DESIGN REVIEW COMMISSION AGENDA

1. Applicant: Magnuson Properties Partnership
Location: 816 E. Sherman Ave.
Request: REQUEST FOR A MEETING WITH THE DESIGN REVIEW COMMISSION FOR RE-APPROVAL OF A 12-UNIT RESIDENTIAL BUILDING AND 2 ADDITIONAL DUPLEX STRUCTURES: TOTALING 16 UNITS (DR-4-24)

**DESIGN REVIEW COMMISSION
STAFF REPORT**

FROM: TAMI STROUD, ASSOCIATE PLANNER
DATE: SEPTEMBER 26, 2024
SUBJECT: DR-4-24: REQUEST FOR A MEETING WITH THE DESIGN REVIEW COMMISSION FOR RE-APPROVAL OF A 12-UNIT RESIDENTIAL BUILDING AND 2 ADDITIONAL DUPLEX STRUCTURES: TOTALING 16 UNITS

SITE PLAN:

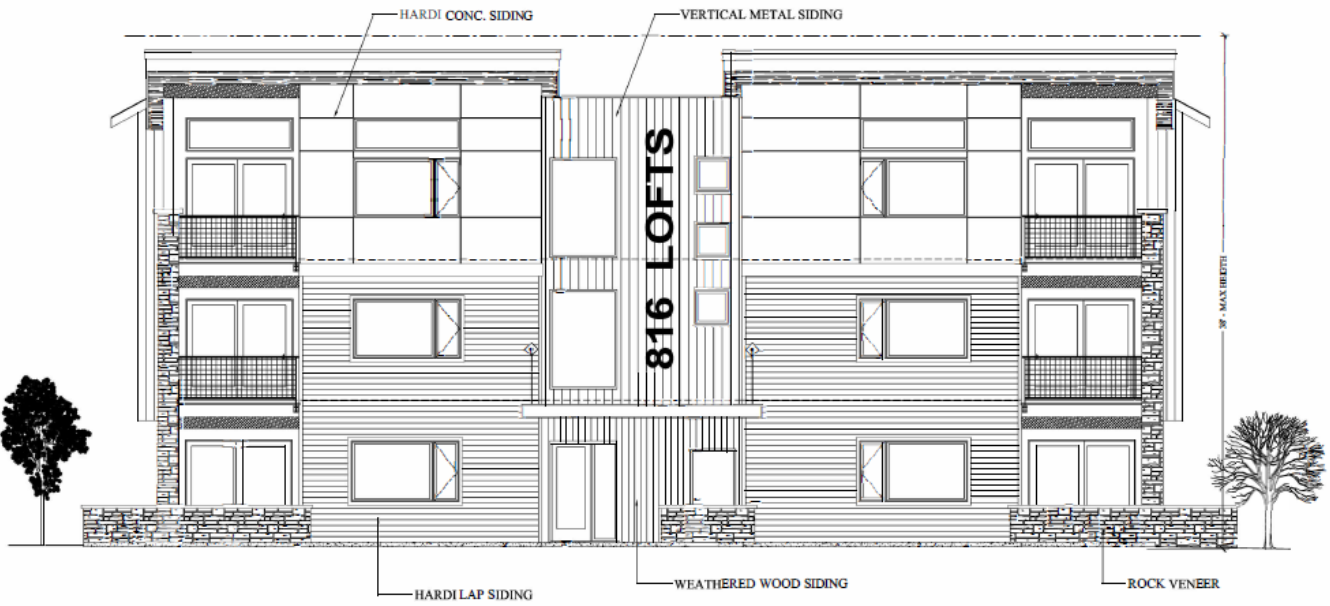
- **Screening of Parking Lots:** Parking area is internally designed and screened by the buildings along both street frontages. Vehicle access will be provided from Front Avenue only to the 12-unit apartment and duplexes. The current Sherman Avenue vehicle access point has been eliminated to lessen Sherman Avenue vehicle traffic thus creating a more residential feel than the commercial through driveway currently in place. The two side abutting properties are screened from the internal parking area by Landscape buffers utilizing Section 1, Type A: plantings and ground cover. Both adjacent properties also have existing partial wood fences/buildings along the parking lot providing existing screening. Refer to Civil Site and Landscape Plan for concept design.

- **Screening of Trash/Service Areas:** A trash enclosure is centrally located within the screened parking area and is away from the public right-of-way. Waste-management vehicle access will be from Front Avenue. The dumpster will be screened from all sides and constructed of 3 sides CMU Block painted to match the building's facade along with a screened entry gate. Refer to Civil Site and Landscape Plan for proposed location.

PRELIMINARY LANDSCAPE PLAN:

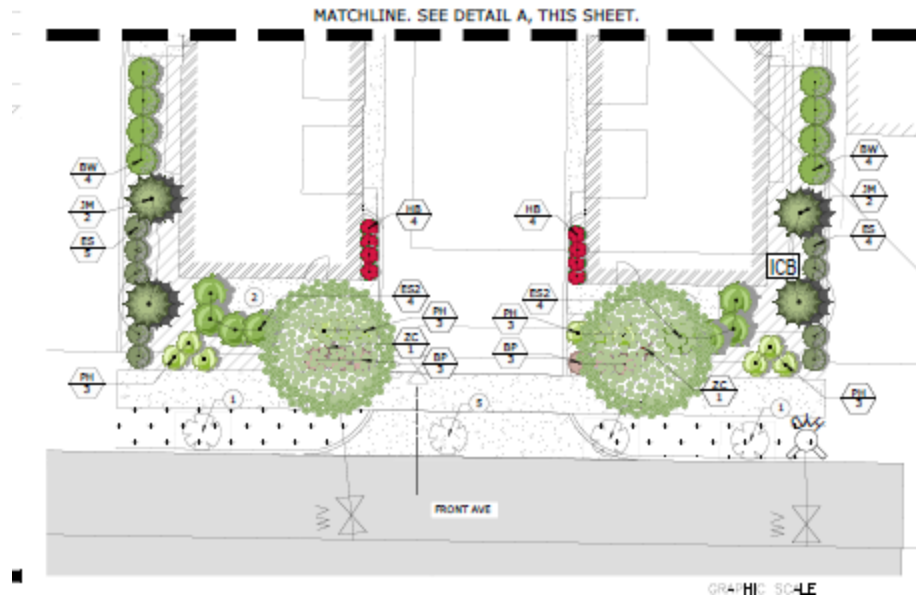
- Landscaping has been provided per the Landscape Plan along the perimeter of the site to meet the landscape design standards. The landscaping includes added street trees and several new landscape areas throughout the site. One Grand Scale tree along Sherman Avenue and two along Front Avenue are to be preserved. **(GENERAL LANDSCAPING)**
- Parking area is internally designed and screened by the buildings along both street frontages. Vehicle access will be provided from Front Avenue only to the 12-unit apartment and duplexes. The current Sherman Avenue vehicle access point has been eliminated to lessen Sherman Avenue vehicle traffic thus creating a more residential feel than the commercial through driveway currently in place. The two side abutting properties are screened from the internal parking area by Landscape buffers utilizing Section 1, Type A:

- In order to reduce the visual mass of parking lots parking lot landscaping around internal parking area is designed to meet City of CDA design standards, including parking lot trees and planter areas. Four new parking lot trees are proposed within the parking lot area and planting areas are provided along the two neighboring properties providing a landscape buffer. Refer to Landscape Plan for concept design. **(PARKING LOT LANDSCAPE)**
